Notice of Meeting of the Historic and Architectural Review Commission of the City of Georgetown, Texas July 9, 2026

Planning Department Staff Report

Report Date: July 1st, 2026
File Number: 2026-33-COA

Project Name: *Richmond Residence II*
Applicant: *Wang Architects*
Property Owner: *Ty Richmond*
Property Address: *1202 Laurel Street*
Legal Description: *Laurel Place, Lot 1&2, 0.909 Acres*
Historic Overlay: *Old Town Overlay District*
Case History: *N/A*
Prior COA Denials: *N/A*
Prior COA Approvals: *2021-48-COA – Remodel and addition to primary structure*

Plans and Specifications - Elevations

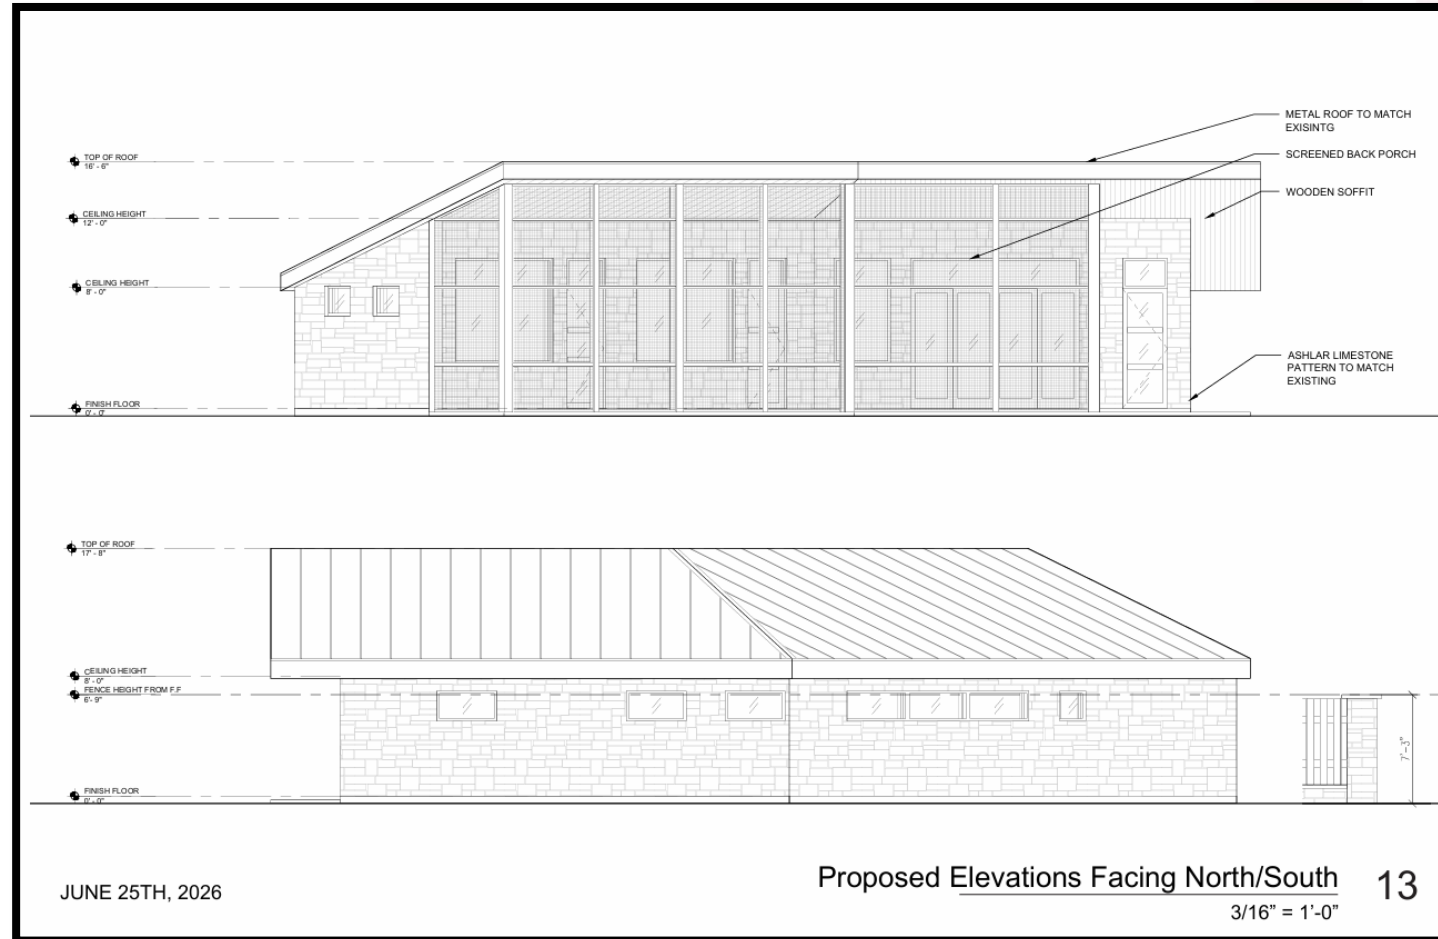
The proposed elevation facing the north features windows that are approximately 5' above the finish floor. The windows are approximately 2' by 4' each and would be blocked from street view with the proposed fence.

b. The proportions of the front façade should be taller than it is wide.	Does Not Comply The structure is 16'-6" tall from finish floor to top of roof, and east-facing façade is 28' in width.

b. The proportions of the front façade should be taller than it is wide.	Does Not Comply	The structure is 16’-6” tall from finish floor to top of roof, and the east facing façade is 28’ in width.

Proposed Site Plan

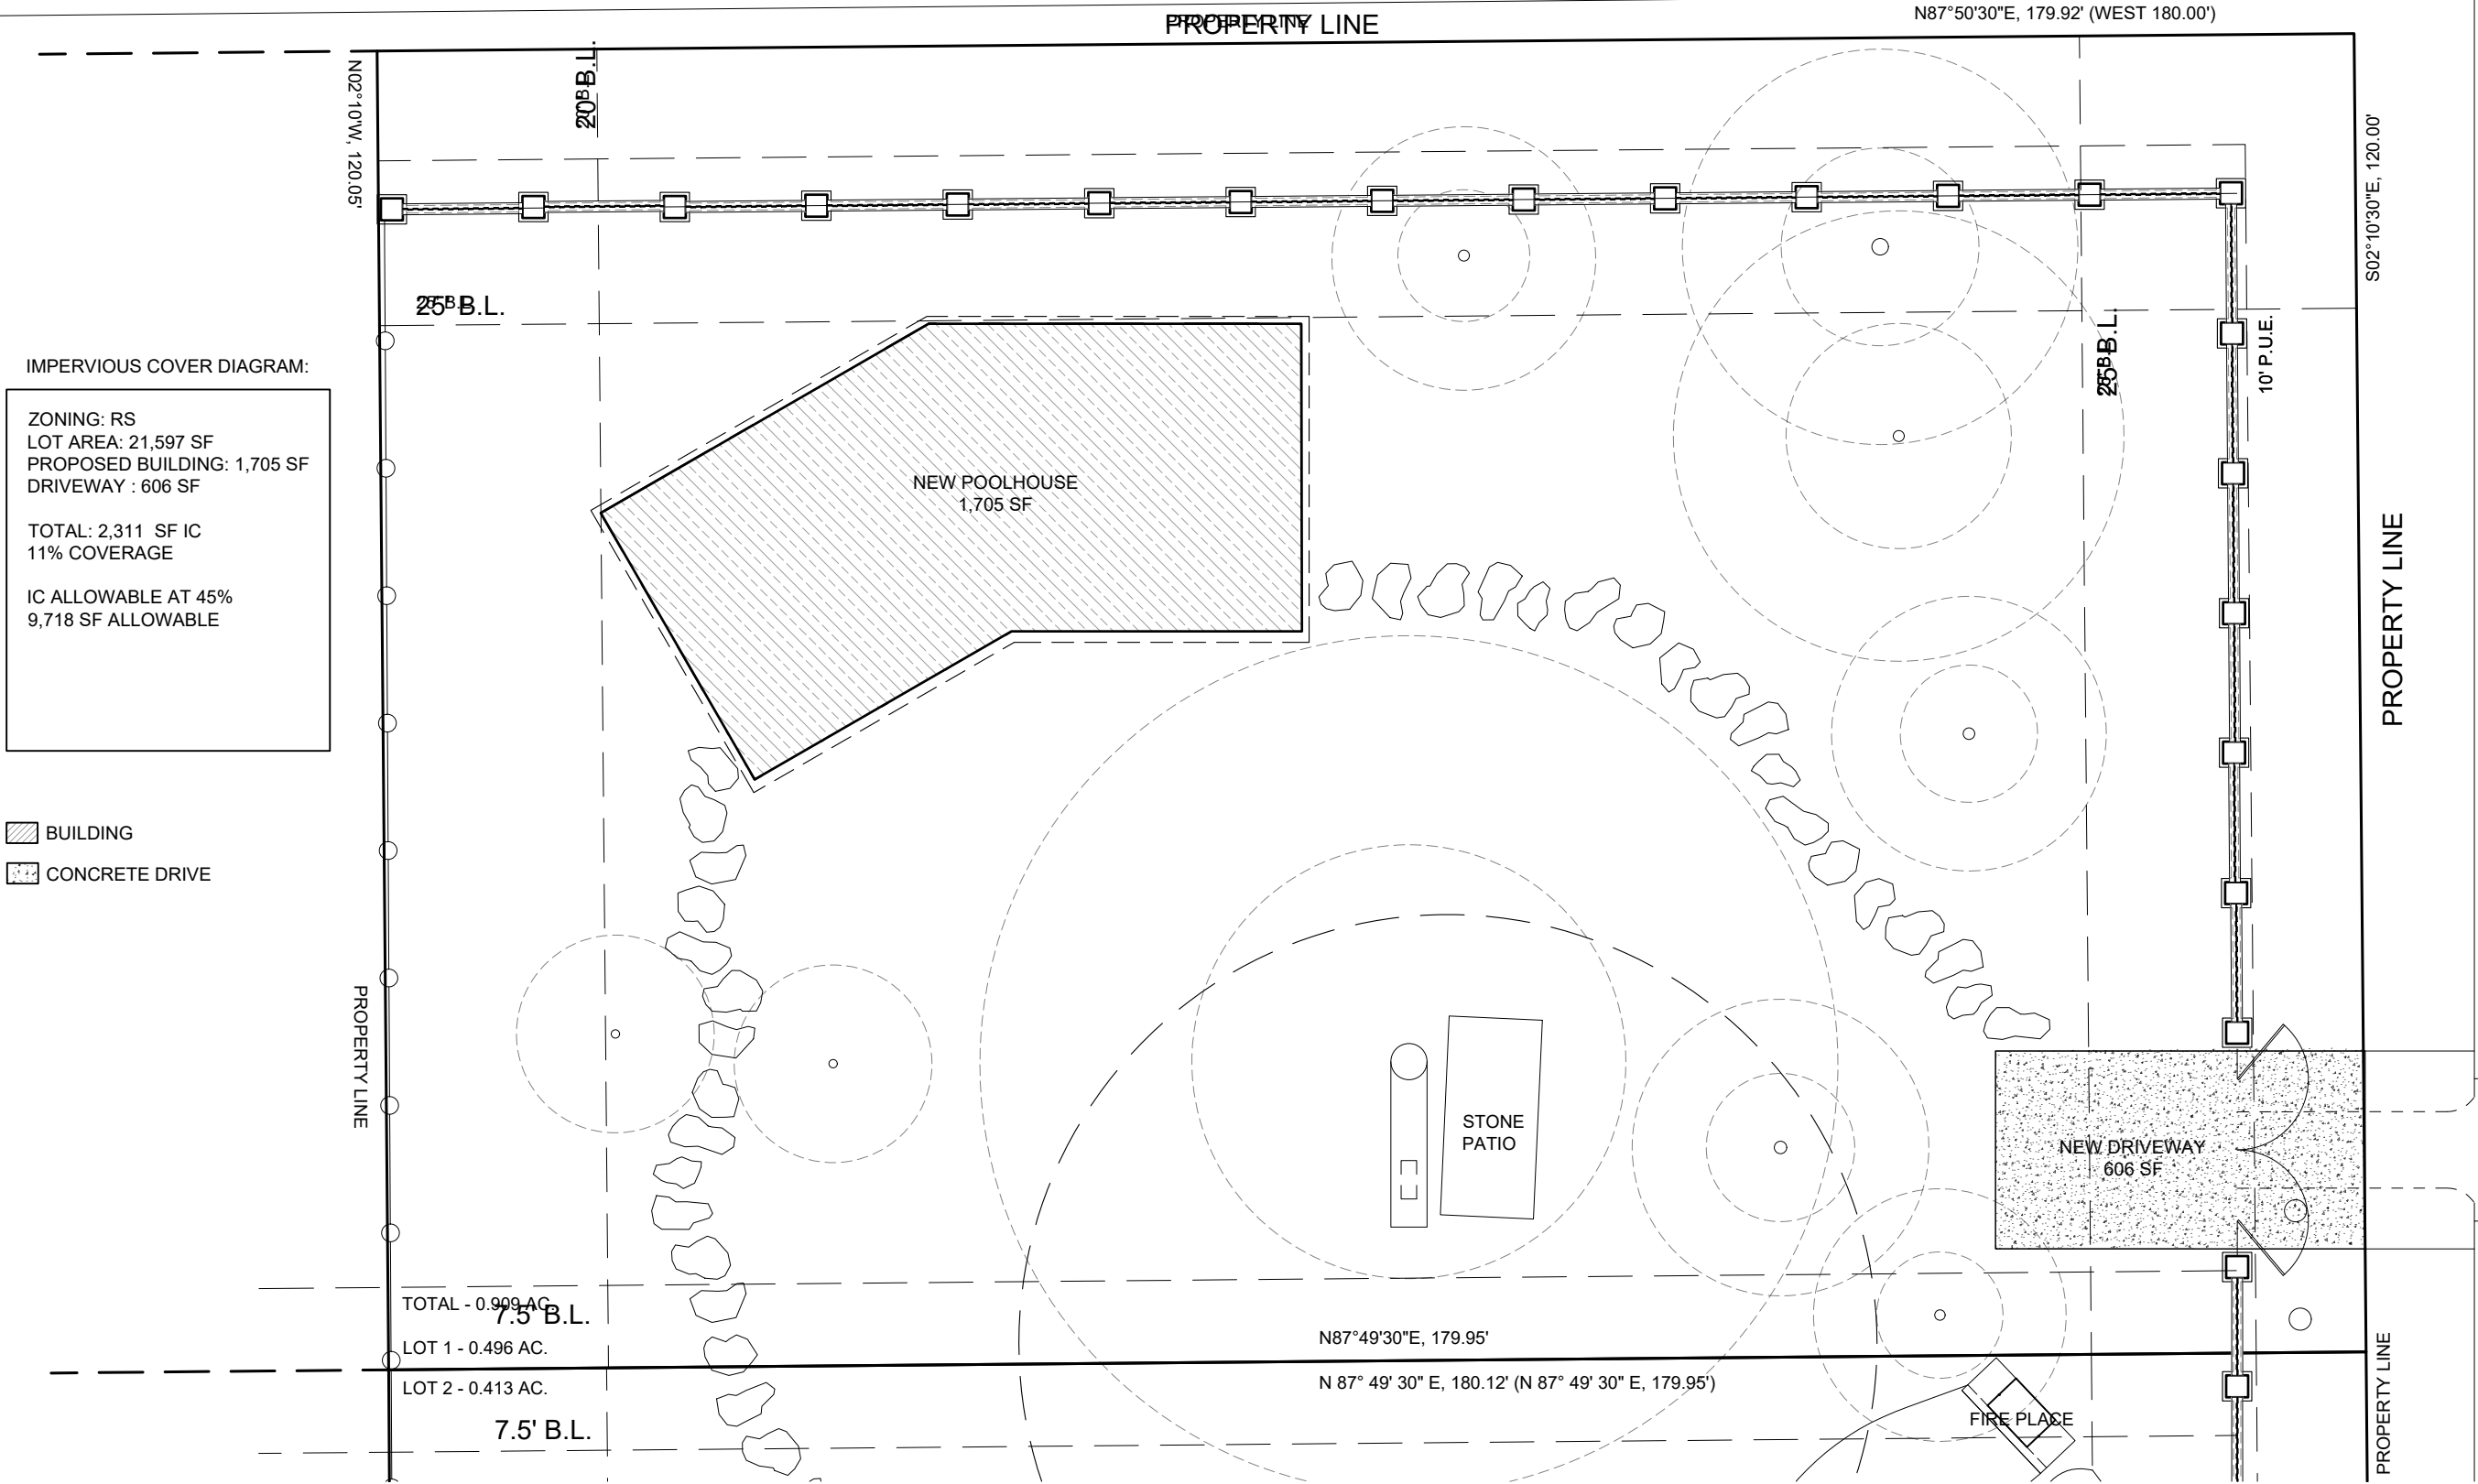
3.4.F Accessory Structures	
F.1 Accessory structures should be located in the rear of the property.	Complies The structure is located behind the primary structure and at the rear of the property.
F.2 Accessory structures should be a simplified historic style of the primary dwelling and should be subordinate (smaller and simpler) to the primary dwelling.	Complies The proposed secondary structure is simplified, smaller, and subordinate to the primary structure
F.3 Accessory structures should not be attached to the primary structure.	Complies The proposed structure is detached from the primary structure.

Ask #3- Additionally, we are requesting a 7'3" height of the street-facing fence line along both University Avenue and Laurel Street. The property is located within the Gateway Downtown Overlay District. Although the property is addressed to Laurel Street, the site has greater frontage and exposure along University Avenue, which has become a heavily traveled corridor over the past decade. The proposed fence consists of 2'-0" x 2'-0" stone columns at 7'-0" in height, each capped with a 3" stone cap for a total column height of 7'-3". Between the columns, there is a 12-inch stone base with a 3" stone cap, above which are 6'-0" vertical wood slats, resulting in a total infill height of 7'-0". The stone columns are spaced approximately 11'–13' on center. We understand that taller fencing (8') has recently been approved along portions of Austin Avenue, and we believe this proposal represents a compatible response to the unique conditions of this site.

Proposed Elevations Facing North/South

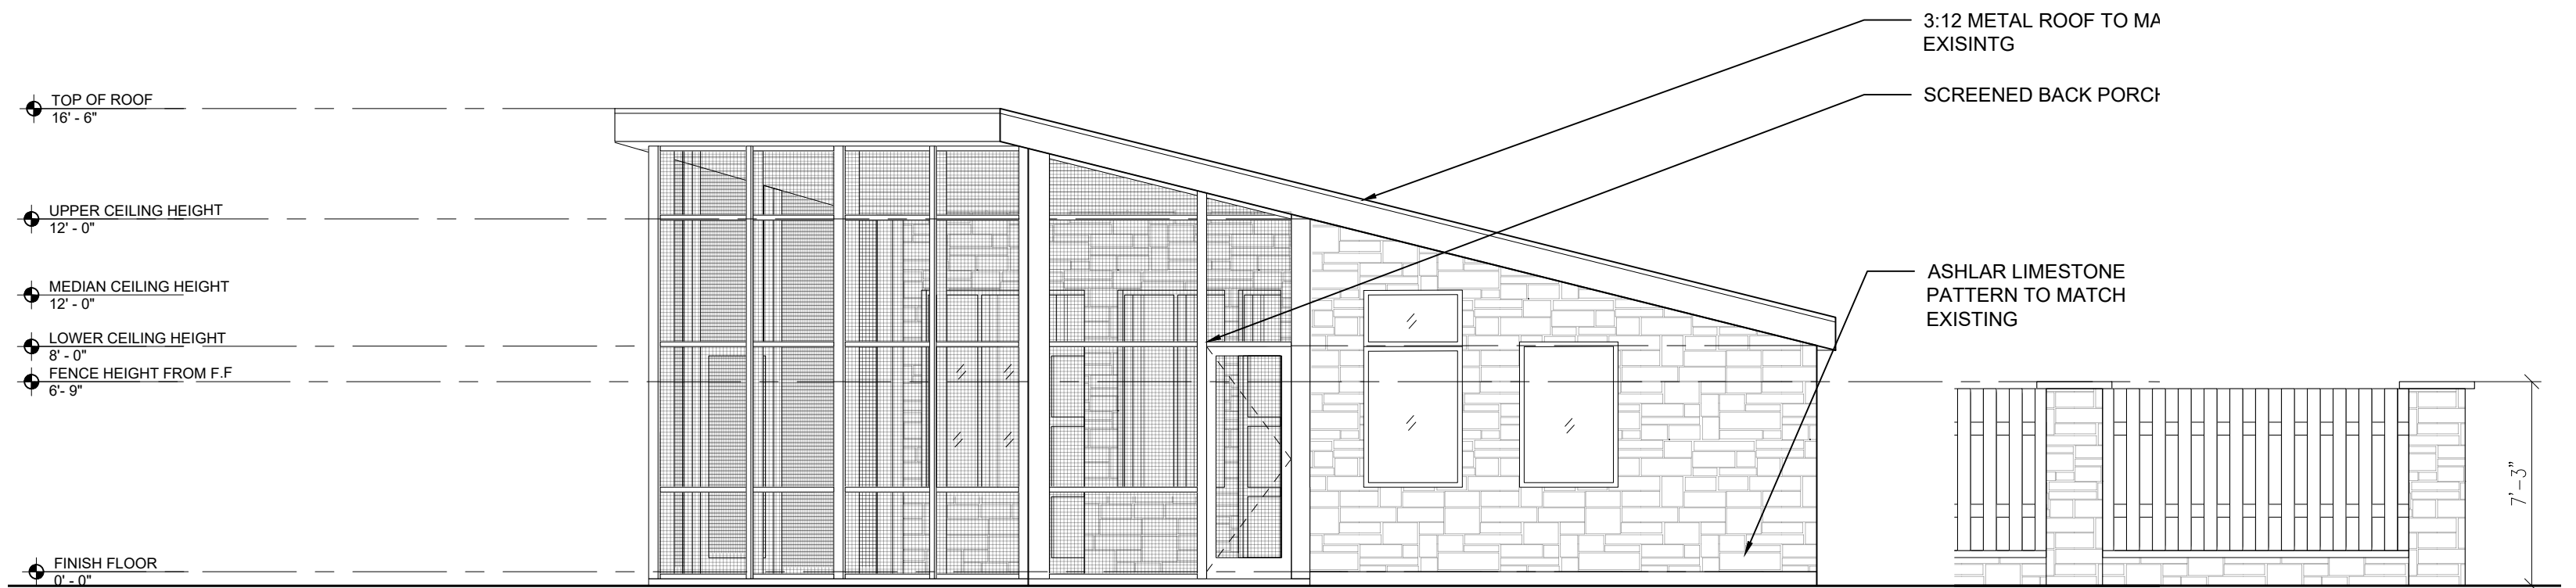
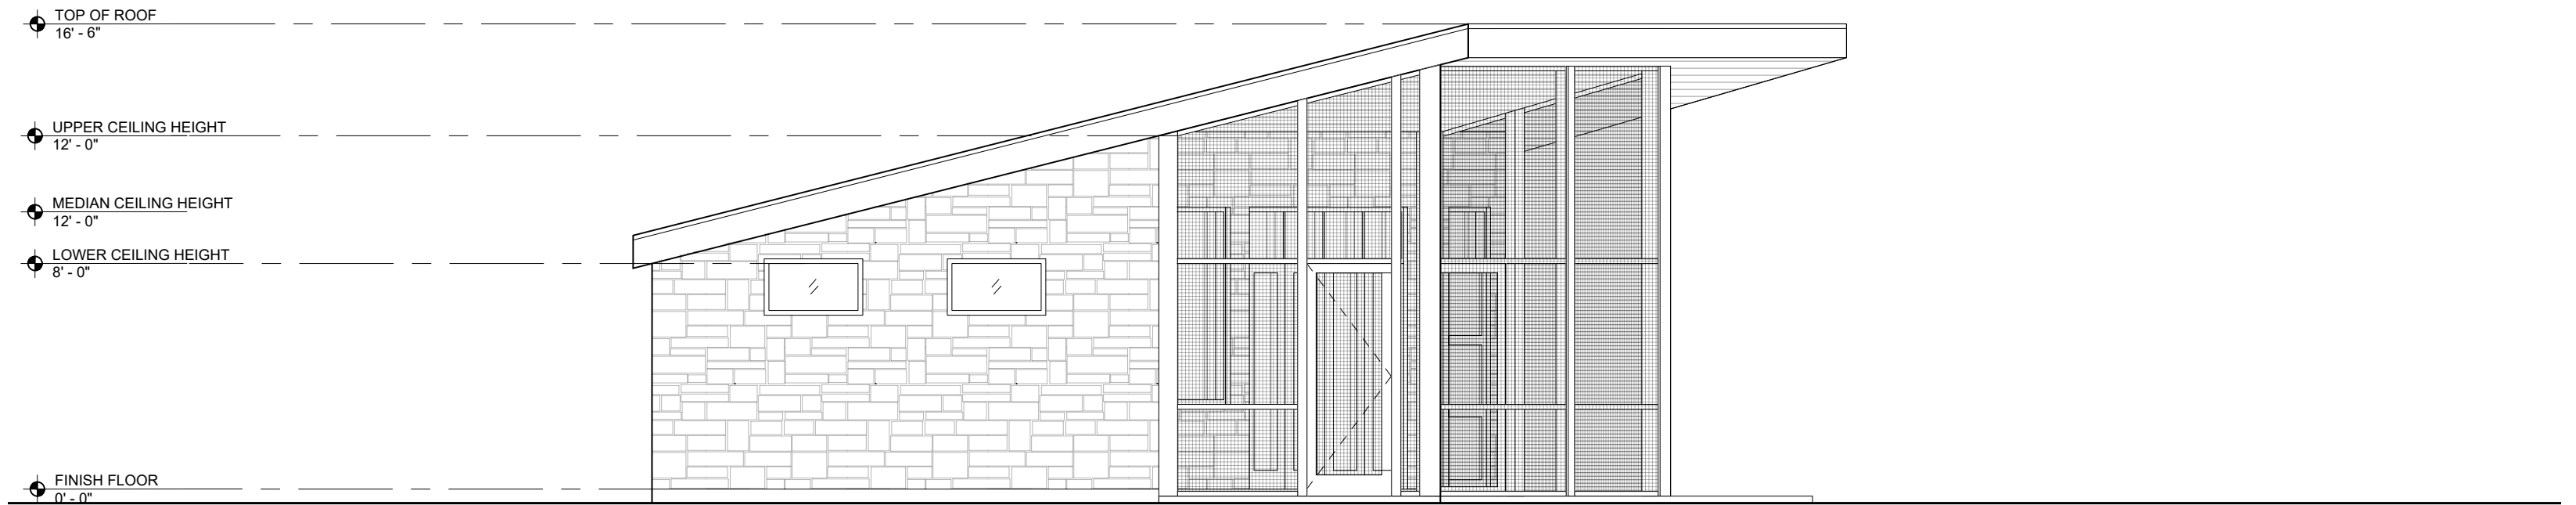
b. The windows should be about twice as tall as they are wide and should have the same sill and head height on each floor of the building. The exception is Modern Ranch houses.	Partially Complies On the façade facing University Avenue, the windows are twice as wide as they are tall.
G.3 Window Materials
